Job No: 2022/4581B
File Ref: N01-PS-Transport Note (260812)
Date: 12 August 2026
Job Title: Cinch Self Storage, Duddery Hill, Haverhill

Subject: Transport Note

1. This Transport Note has been prepared in relation to the former Arriva Vauxhall site on Duddery Hill in Haverhill. Planning approval was granted in October 2024 (application reference 23/1702/FUL) for the demolition of the existing building (retrospective) and construction of a new building arranged over ground, first and second floors for Class B8 (self-storage) purposes with associated vehicular and cycle parking and landscaping. The site will be operated by Cinch Self Storage.

Proposed Site Layout Plan

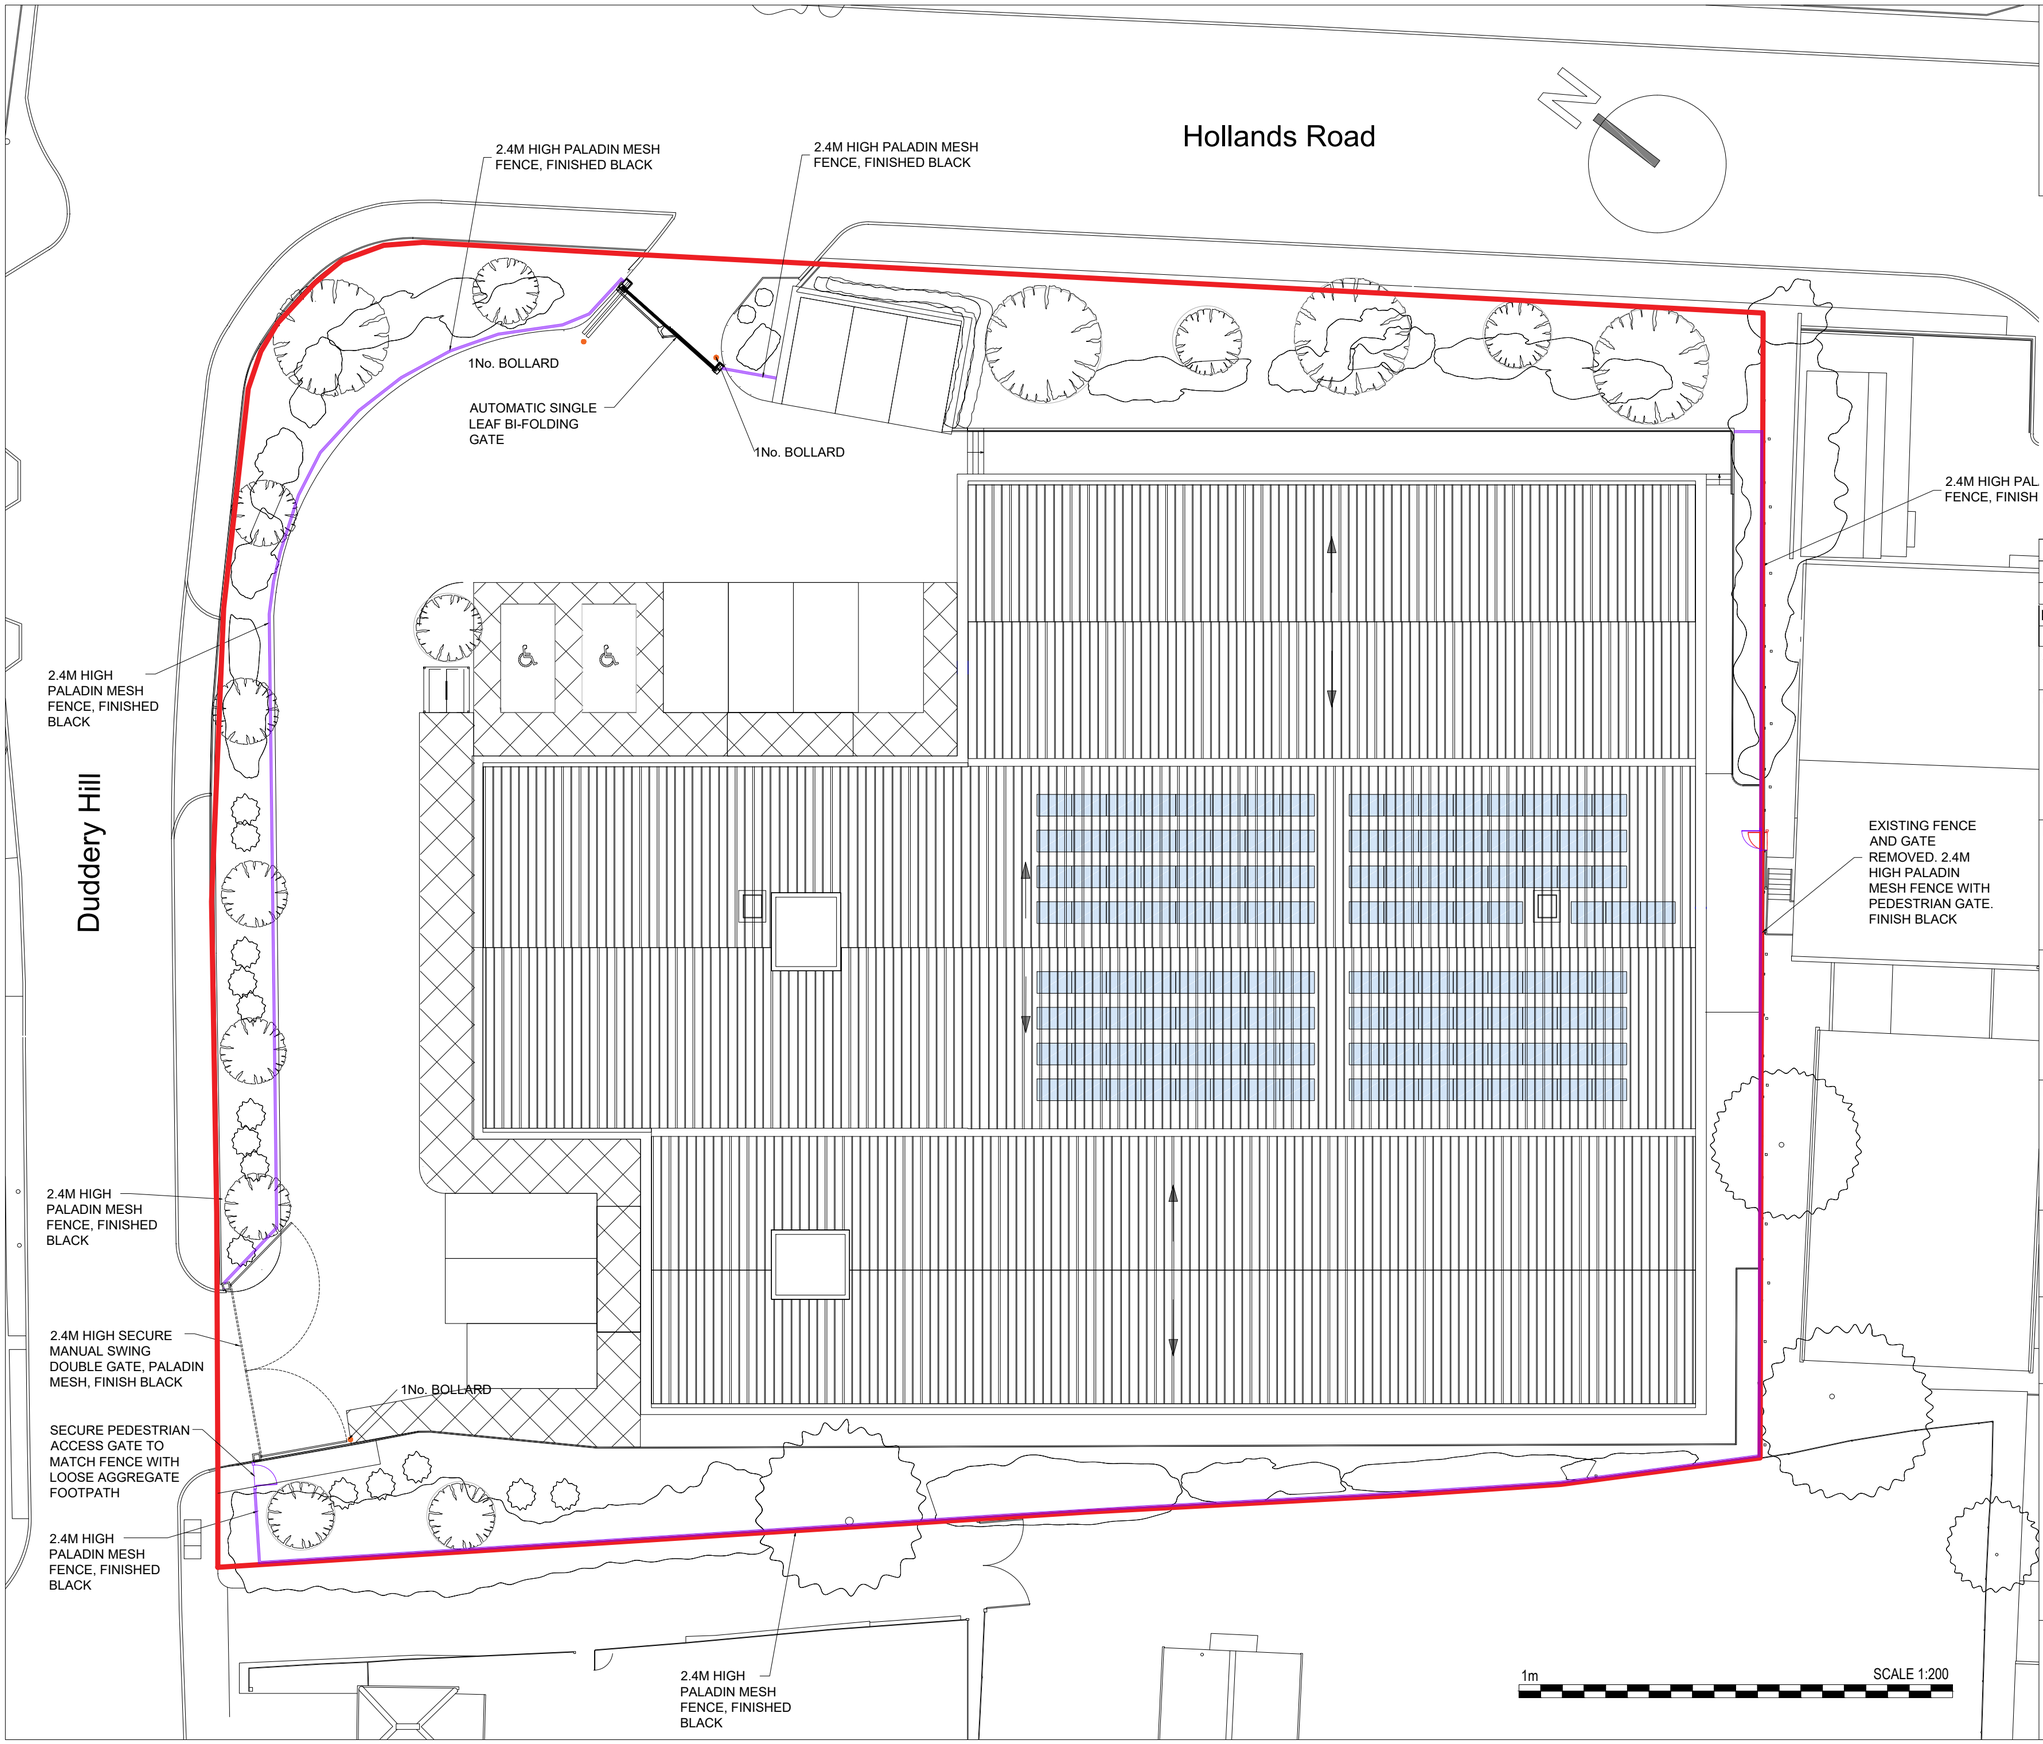
"Any gates/bollard/chain/other means of obstruction to the access shall be set back a minimum distance of 5 metres from the public highway and shall not open towards the highway. This should be demonstrated prior to any formal recommendation can be made."

5. The site has two points of vehicular access, one on Hollands Road and the other from Duddery Hill. The plan at Appendix A shows that the gates on Duddery Hill are set back slightly from the public highway, but not as much as the 5 metre distance requested by the Highway Authority as this would result in the gates being located on the circulatory route around the site, which would obstruct vehicle movement to and from the access.

6. The position of the gates on Hollands Road has been reviewed to ascertain whether they could be positioned to accord with the County Council's request but the gradient of the

site in this area means that this is not feasible. No gates would open outwards onto the public highway.

8. The site gates will be mechanically controlled with a remote opening function that will enable the member of staff opening the gates to do so without needing to leave their vehicle therefore minimising time that a vehicle would be waiting on the public highway. When leaving the site at the end of the day, the member of staff would be able to close the gates remotely from their vehicle, meaning that they would only wait on the carriageway outside the site for the time it takes gates to close. It is not considered that a staff vehicle waiting momentarily on the carriageway before 7am and after 7pm would inconvenience users of the public highway or have a material effect on the operation of the local road network.
